Town of The Blue Mountains

Date: January 24, 2024

Re: Lakewood Drive Reconstruction Project - Public Information Centre #1

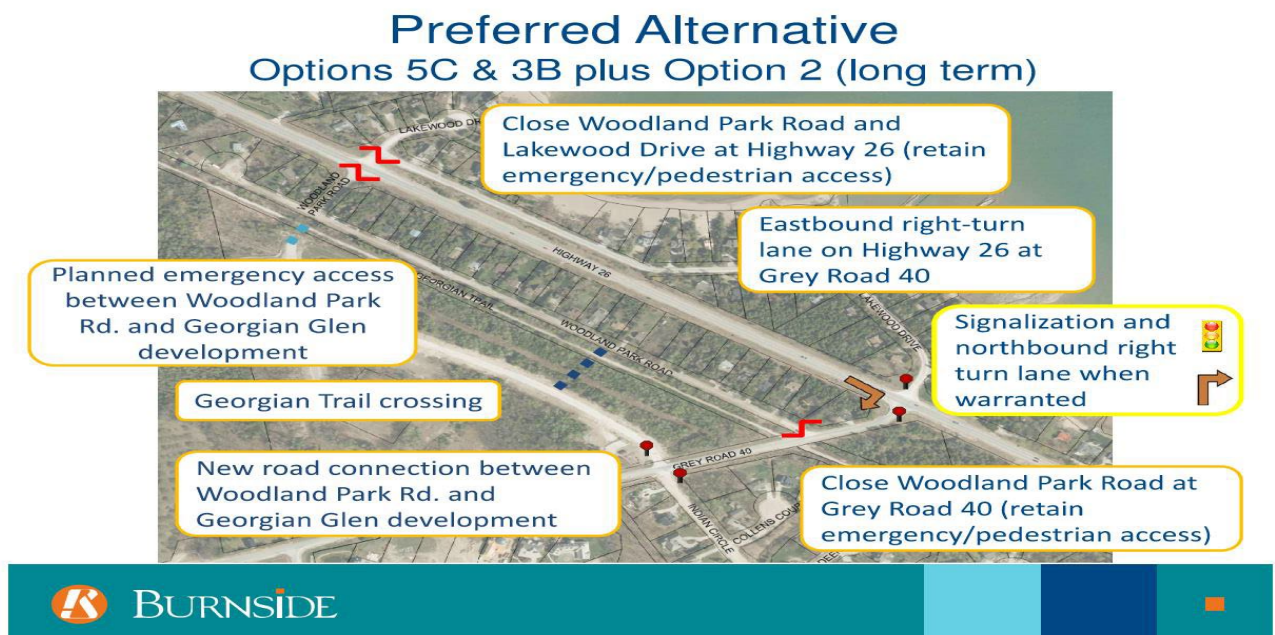
Attendees and residents brought forward concerns about vehicles speeding on Lakewood Drive and Highway 26, along with highlighting the difficulty of crossing Highway 26 as a pedestrian. There are three specific items which they would like to see considered which include: Installation of a traffic light at the intersection of Highway 26 and Grey Road 40, reduction of the speed limit on Highway 26 to 70 km/h, and reduction of the speed limit on Lakewood Drive and Woodland Park Road to 30 km/h.

Staff Response: The Highway 26 / Grey Road 40 Intersection Improvements Municipal Class Environmental Assessment's Preferred Alternative is shown below. Traffic lights are recommended when warranted. Council rejected the closure of Woodland Park Road and Lakewood Drive which could extend the time before the warrants trigger the installation of traffic lights.
